# UNITED STATES PATENT AND TRADEMARK OFFICE

APPLICATION NO.	FILING DATE	FIRST NAMED INVENTOR	ATTORNEY DOCKET NO.	CONFIRMATION NO.
09/841,666	04/24/2001	Mitsuhiro Tanaka	70868/55581	6486
21874	7590	11/18/2005	EXAMINER	
EDWARDS & ANGELL, LLP P.O. BOX 55874 BOSTON, MA 02205			NGUYEN, HOAN C	
			ART UNIT	PAPER NUMBER
			2871

<b>Office Action Summary</b>	<b>Application No.</b> 09/841,666	<b>Applicant(s)</b> TANAKA ET AL.	
	<b>Examiner</b> HOAN C. NGUYEN	<b>Art Unit</b> 2871

**DETAILED ACTION**

【図1】

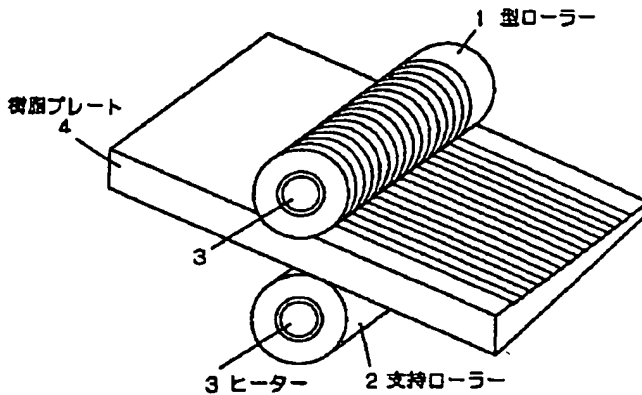
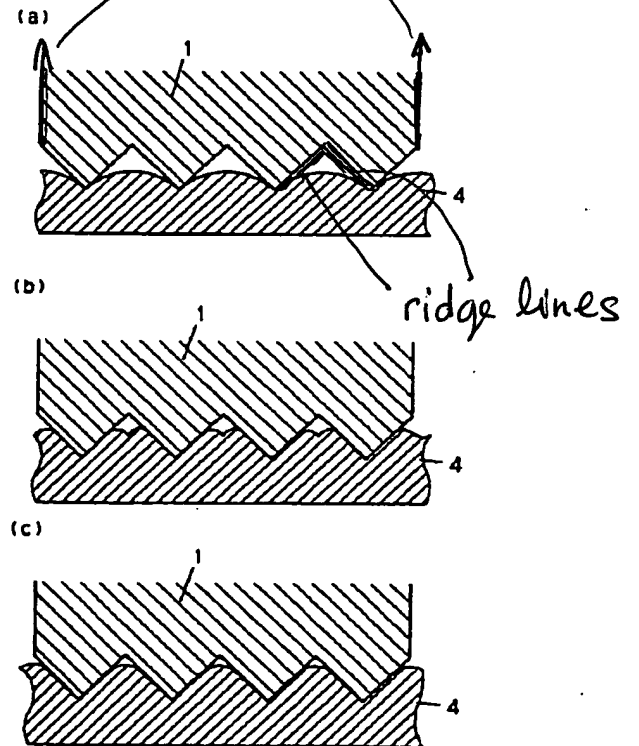
Michihara et al. (Figs. 1, 3, 8 and 9) an apparatus for producing an optical film comprising:

- a cylindrical die roller (mold roller as Fig.1 shown) having a matrix formed on a surface thereof in which a plurality of rows of concave portions or convex portions that are linearly continuous are regularly arranged so as to be adjacently formed in parallel with one another and being defined with ridge lines (the sides of a groove consider as ridge lines) so as to be inclined at a predetermined angle with respect to a circumferential direction (the end surface consider as circumferential direction) of the die roller (continuous V groove), wherein the predetermined angle is 10-80 degrees as clearly shown in Fig. 3 [ the V-groove depth of 5 microns and the V-groove interval of 200-300 microns, thus the inclined angle is in a range of 10°-80°].

- means (the heat roller type imprint press as Fig. 2 shown) for transferring a rough face of a die film to a surface of another film, the rough face resin plate 4 being produced by rotating the die roller on the die film and having convex portions or concave portions that are linearly continuous.
